SITE INSTRUCTION #4**Project Name: Hampton Manor (25 Baker Hill Boulevard) - Stouffville****Project Number: 20140490****Vince Staffieri****August 25, 2017****Royal Pine Homes****3550 Langstaff Road, Suite 200****Woodbridge, Ontario L4L 9G3****via email: vince@royalpinehomes.com**

A. REFERENCE:

- .1 Drawings S1-01, S1-02 AND S5-01

GROUND FLOOR FRAMING PLAN
S1-02

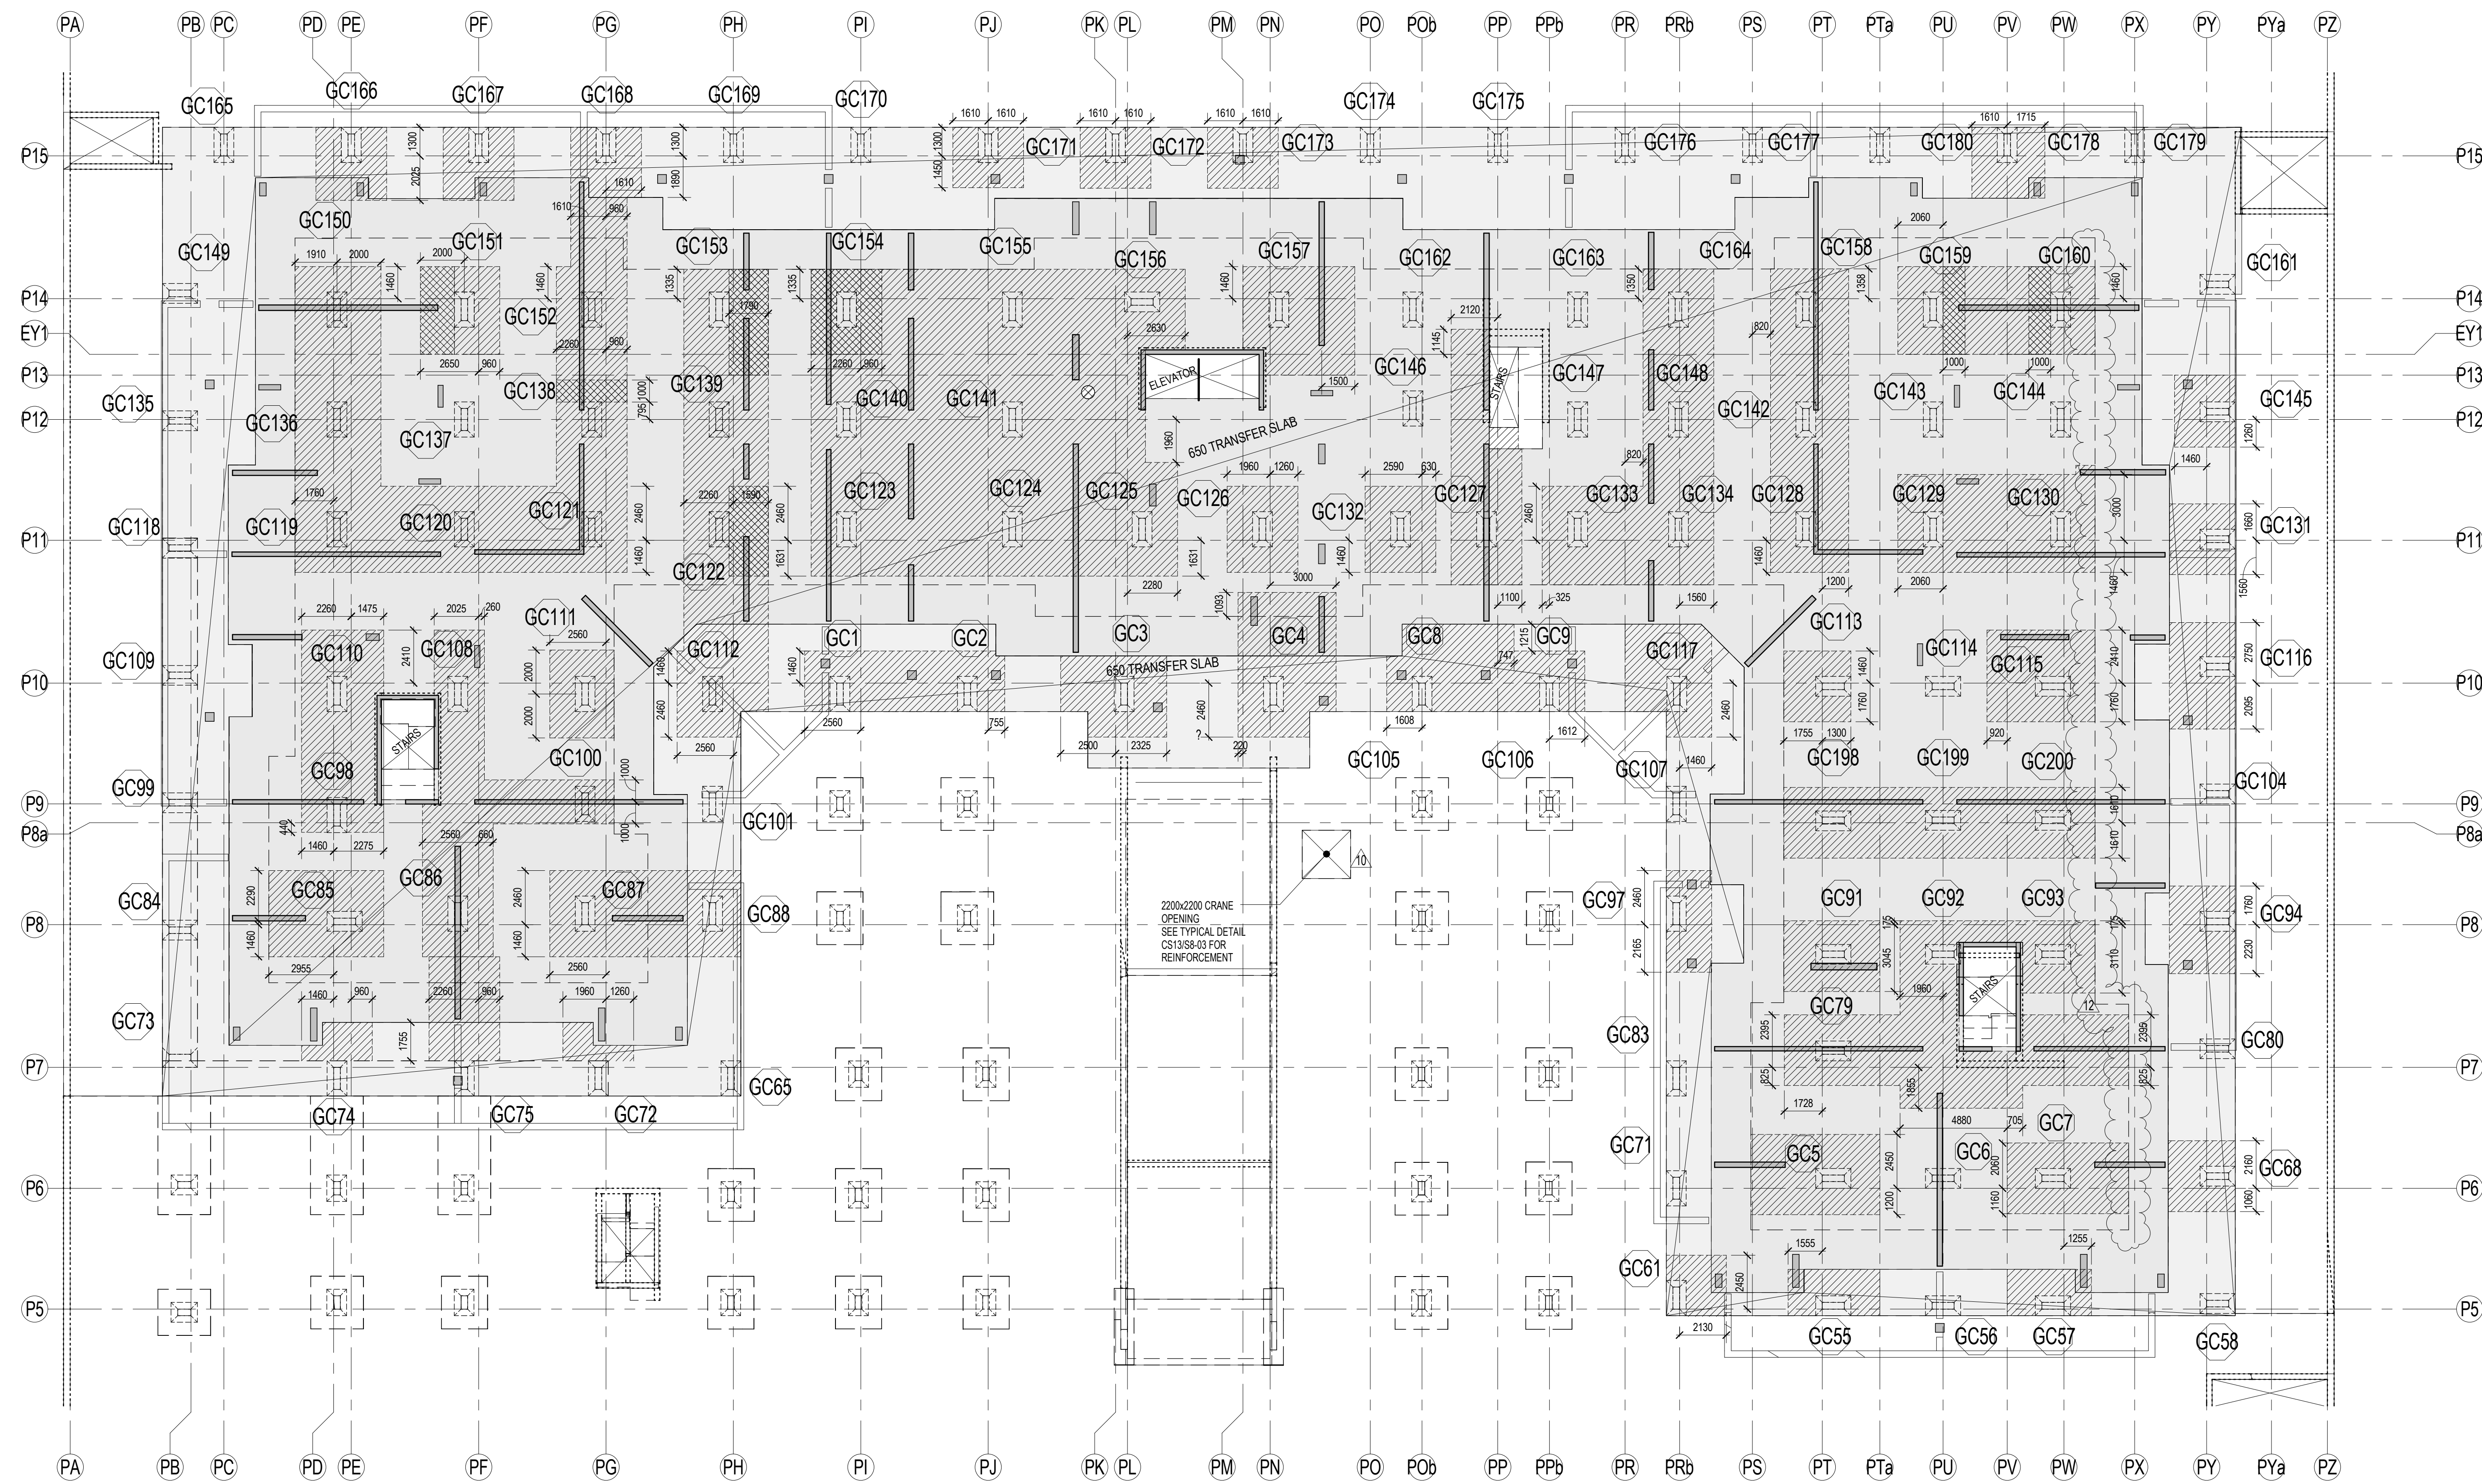
- .1 Revise ground floor slab soffit as indicated.
